SUNDRY NOTICES AND REPORTS ON WELLS
Do not use this form for proposals to drill or to re-enter an abandoned well. Use form 3160-3 (APD) for such proposals.

1. Type of Well <input checked="" type="checkbox"/> Oil Well <input type="checkbox"/> Gas Well <input type="checkbox"/> Other	8. Well Name and No. MCINTYRE B 8
2. Name of Operator COG OPERATING LLC Contact: KANICIA CASTILLO E-Mail: kcastillo@concho.com	9. API Well No. 30-015-31562
3a. Address 600 W ILLINOIS AVE MIDLAND, TX. 79701	3b. Phone No. (include area code) Ph: 432-685-4332
4. Location of Well (Footage, Sec., T., R., M., or Survey Description) Sec 20 T17S R30E Mer NMP 990FSL 990FWL	10. Field and Pool or Exploratory Area LOCO HILLS; GLORIETA YESO <i>Graham Jackson SR-0650</i> 11. County or Parish, State <i>28509</i> EDDY COUNTY, NM

COG Operating LLC, respectfully requests to recompleate to the San Andres as follows:
MCINTYRE B #8

Mcintyre B 8
30-015-31562
COG Operating LLC
April 17, 2018
Conditions of Approval

**COG Operating LLC
PROPOSED**

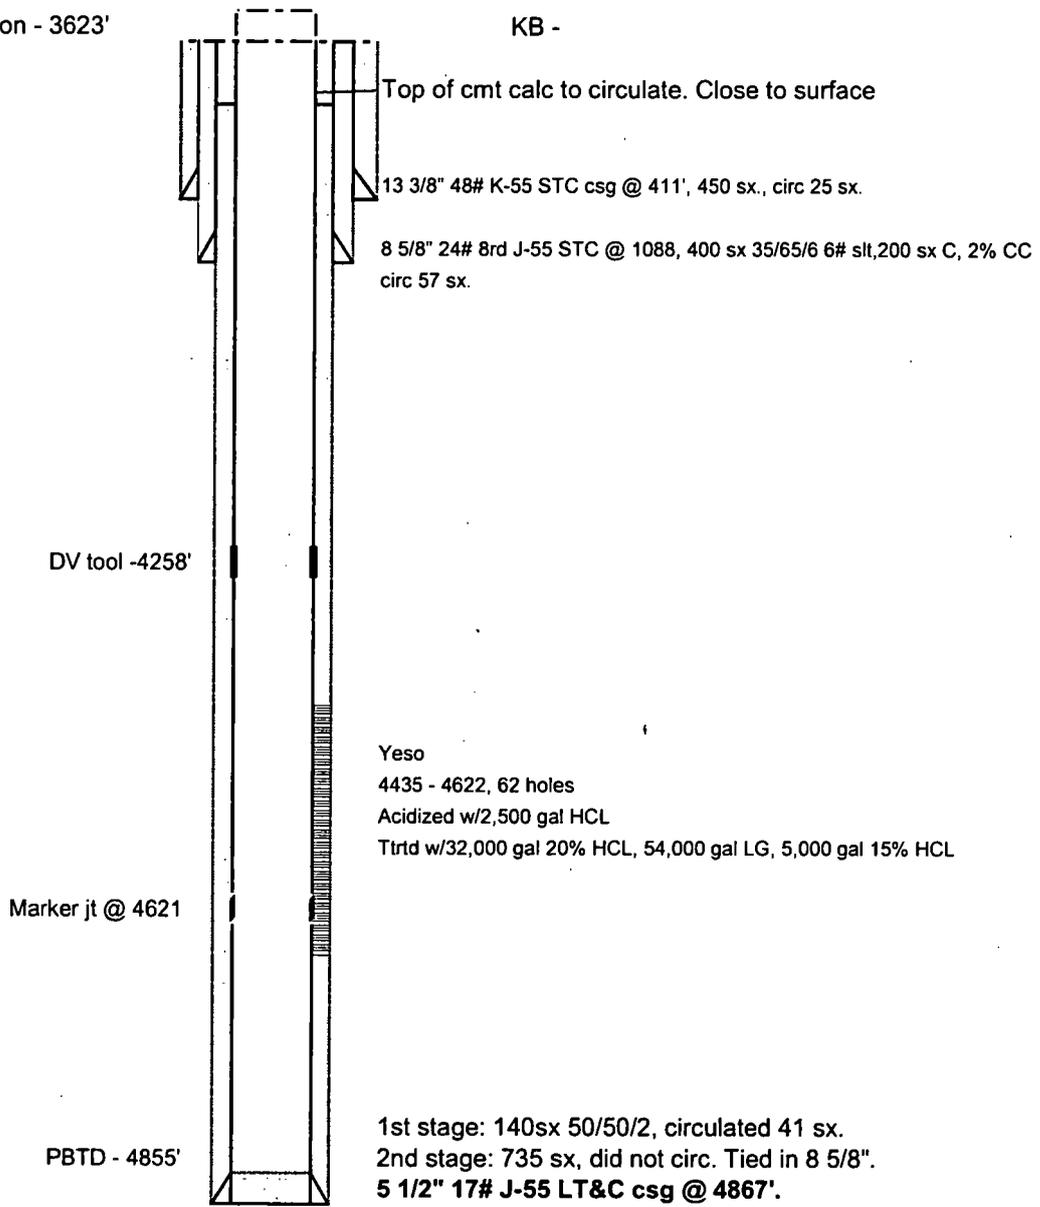
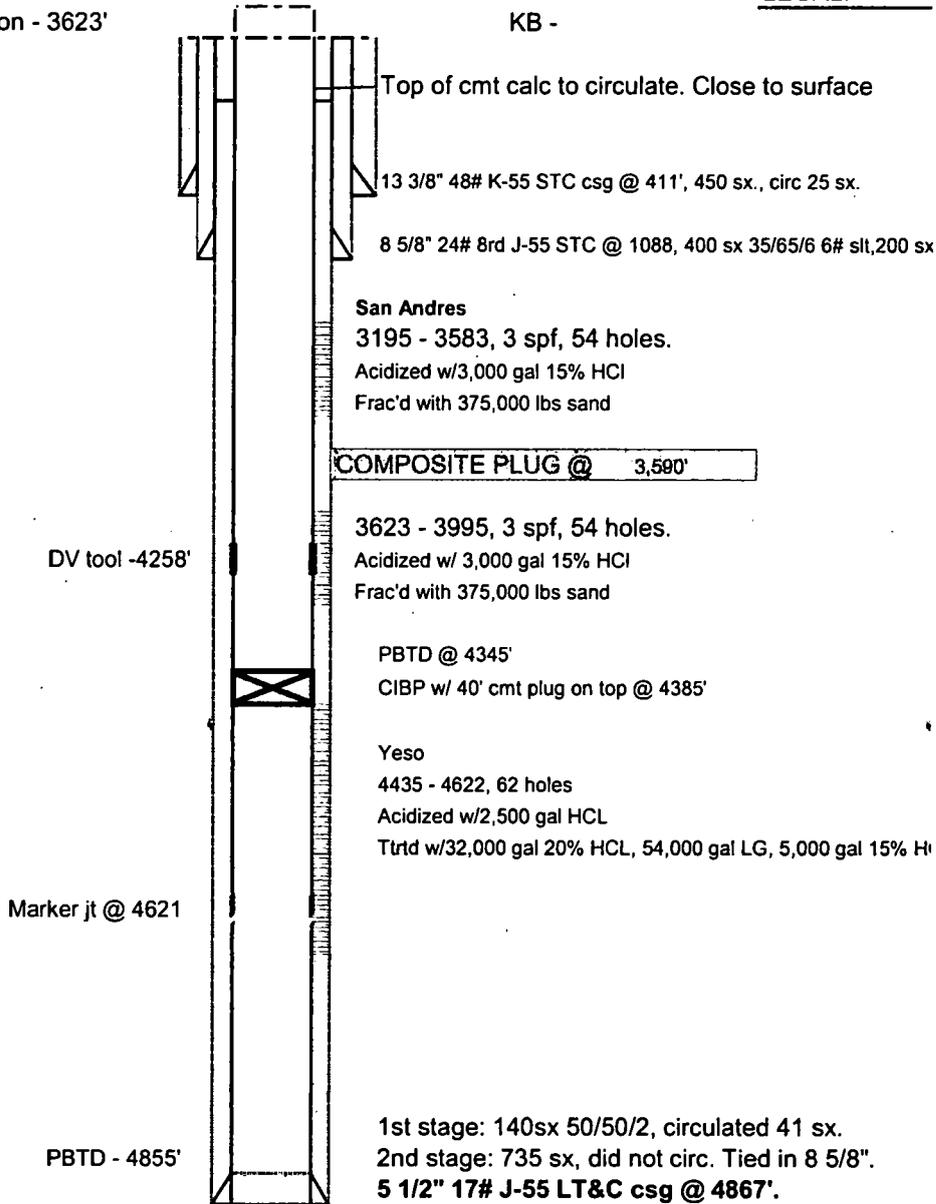
- 1. Operator shall place a CIBP at 4,385' and place 40' Class C Cement on top of the CIBP. WOC and TAG.**

Note: At a later date, operator will need to add 110' of cement to the CIBP to properly seal the Glorietta Formation.

- 2. Must conduct a casing integrity test before perforating and fracturing. Submit results to BLM. The CIT is to be performed on the production casing to max treating pressure. Notify BLM if test fails.**
